PP-08816251 – Landscaping Application: 11 Briardale Gardens NW3 7PN

08 October 2020

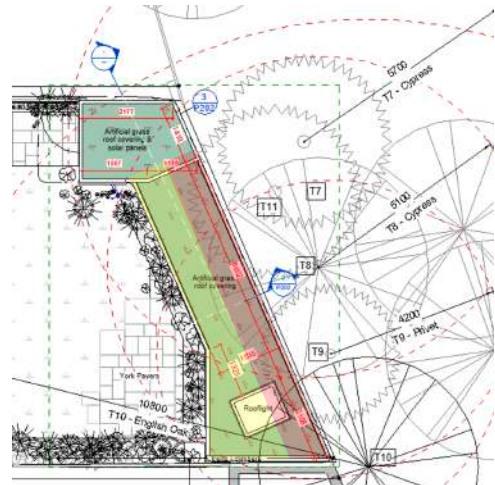
The images below illustrate the difference in levels and the width of proposals measured out on site.

Neighbours fence footing  
Proposed top of slab

Width of proposed shed / bike store.

- Zone requiring cutting into slope.
- Zone requiring lowering approx 150mm for slab to abutt neighbour's fence footing.
- Extent of shed above existing ground levels

Extract of submitted drawings marked up to show the lower section through the slope and lesser depth of proposal below ground.

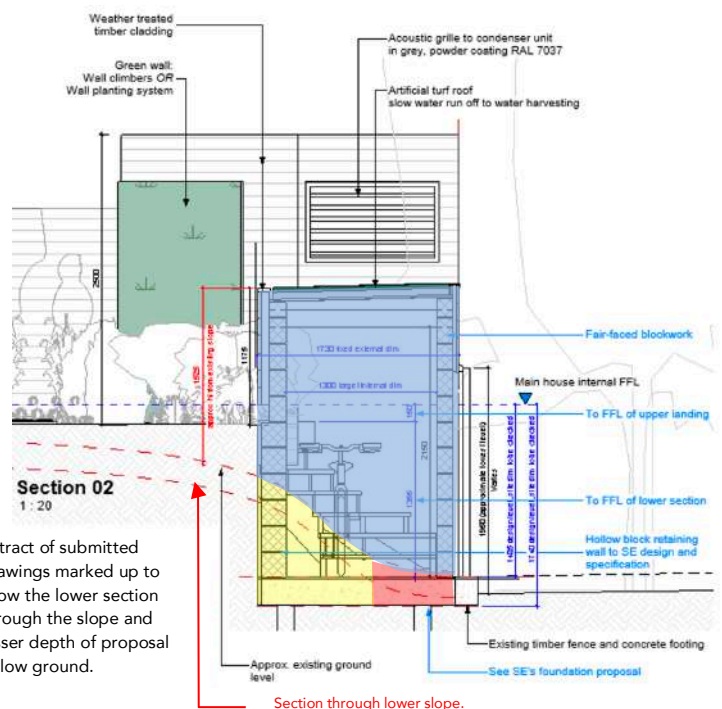
The red dashed line on the submitted section (1901\_FS\_P202) illustrated the highest, pre-construction, level of the slope. This varies and the consented removal of trees and roots bowls of T1-T4 has reduced existing levels further in local areas. So, the submitted section is a generous illustration of the degree of re-grading required.

After clearance of overgrowth, the slope line is approximately 100 mm less than previously indicated. The land also slopes towards the Finchley Road and the lower section through the slope is indicated on a markup of submitted section 02 (opposite).

Please advise how much lower the new building slab needs to be from the prevailing ground level to be considered a basement. At present the new slab is at 1000 mm below the prevailing garden level so well over half the height of the shed is above ground on three sides. If you look at the particular conditions of this site, the depth of excavation along the wall line is closer to 800mm and decreases with the slope as illustrated above. There is a need to grade levels (up) to provide level access to the shed from general garden level. These factors illustrate that excavation is limited and the majority of the shed is above ground – does this constitute basement development?
